BULLETIN

NUMBER 124

SUBJECT: PA-22 Landing Gear

MODELS AFFECTED: All Model PA-22 Airplanes

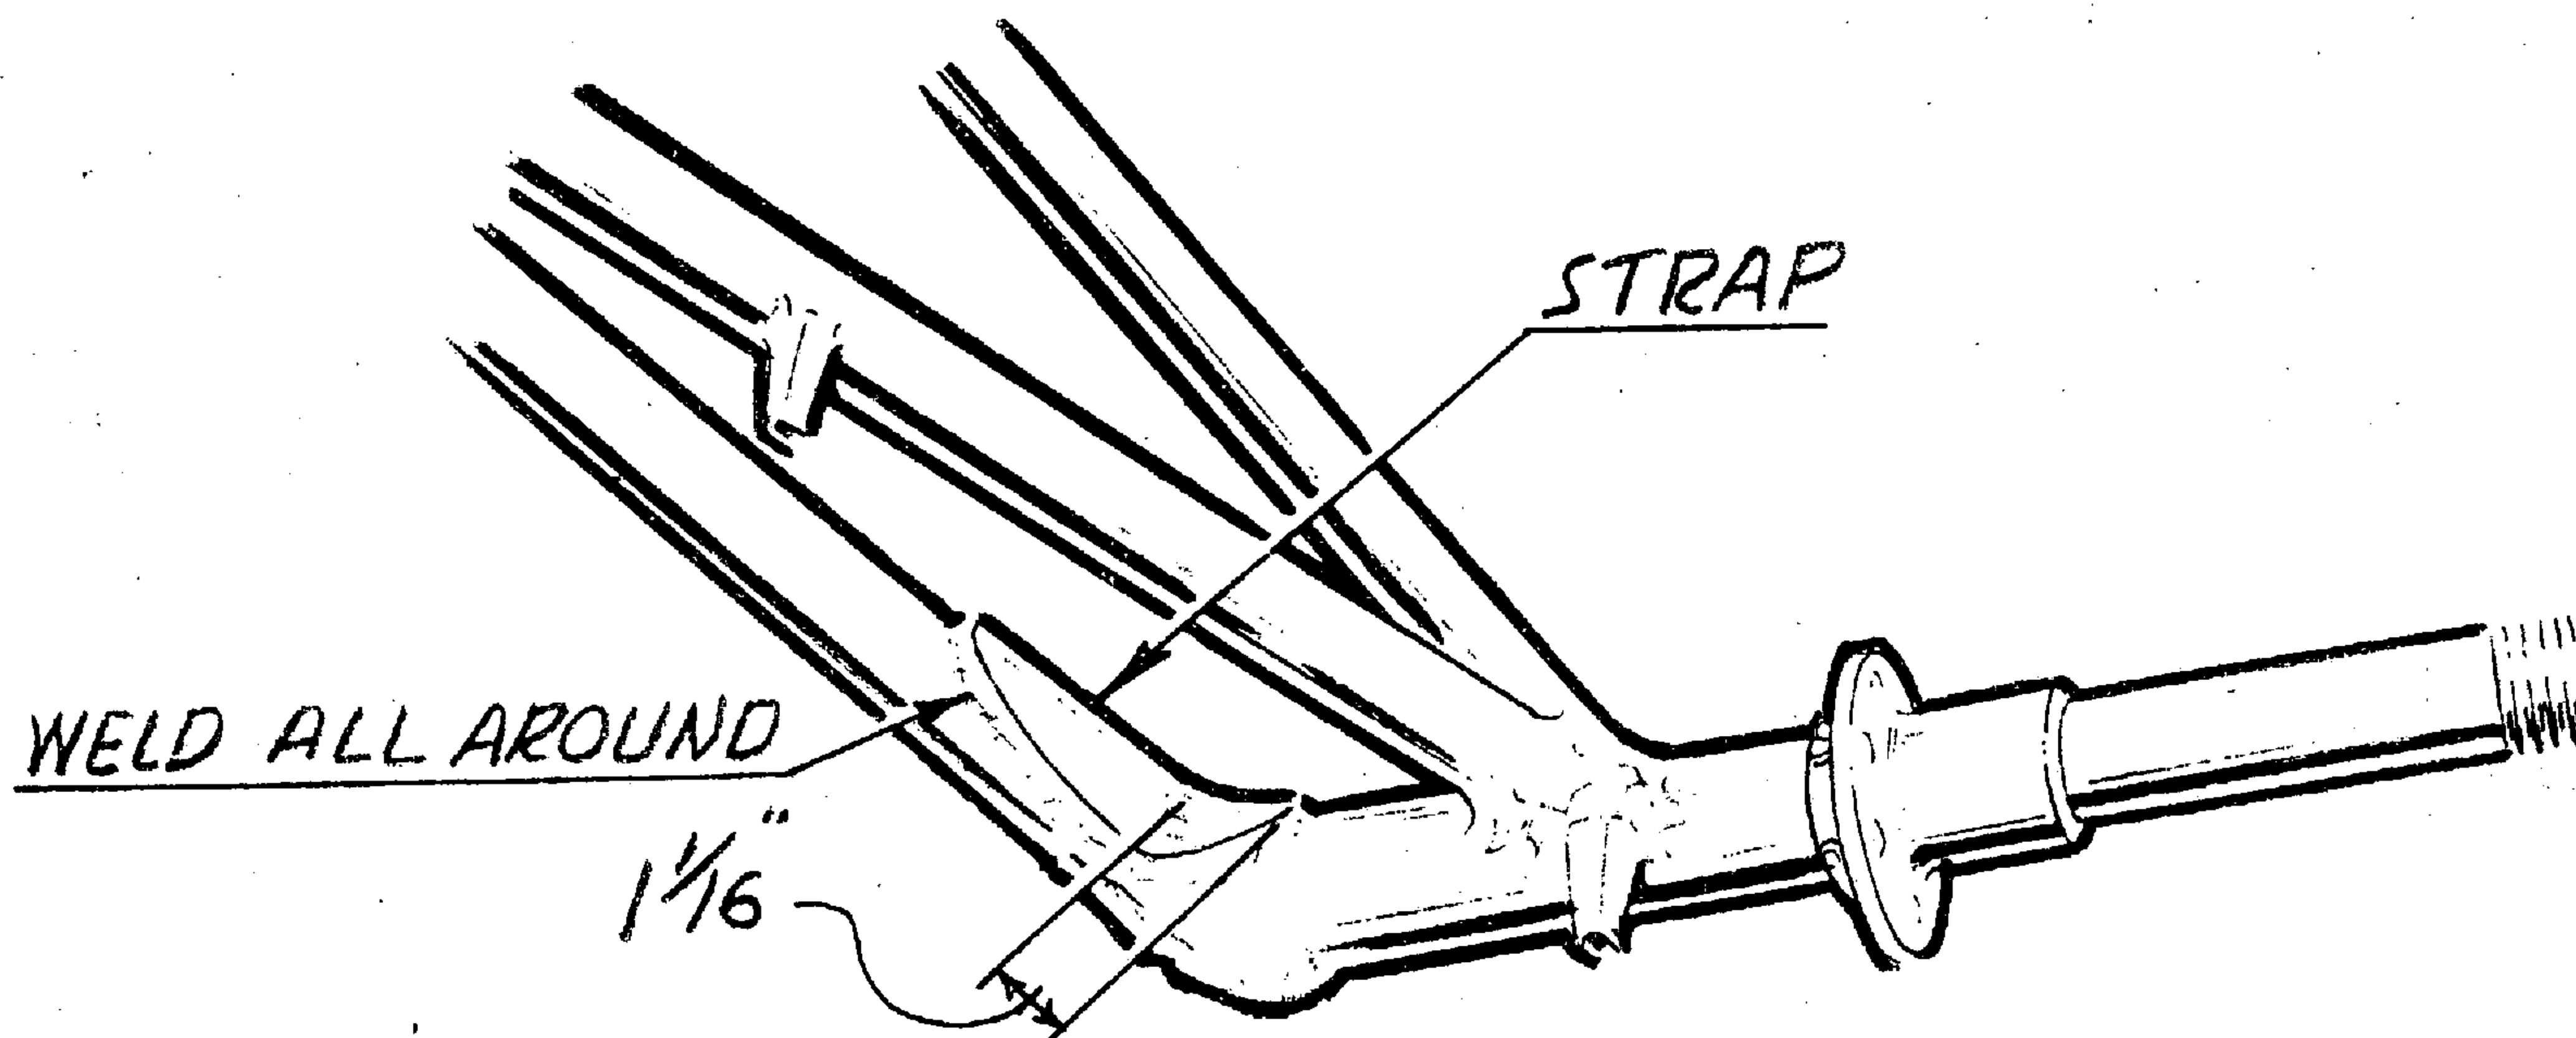
A number of field service reports have been received to the effect that cracks have been appearing in the leading edge of the streamlined tube of the PA-22 landing gears at a point where it joins the inboard end of the axle.

Indications are that this is a fatigue failure and it is requested that all Model PA-22 airplanes listed above be modified by installing a reinforcing strap, part number 14415-00, as per the sketch below.

The reinforcement strap can be obtained from the Service Department of the Piper Aircraft Corporation, free of charge.
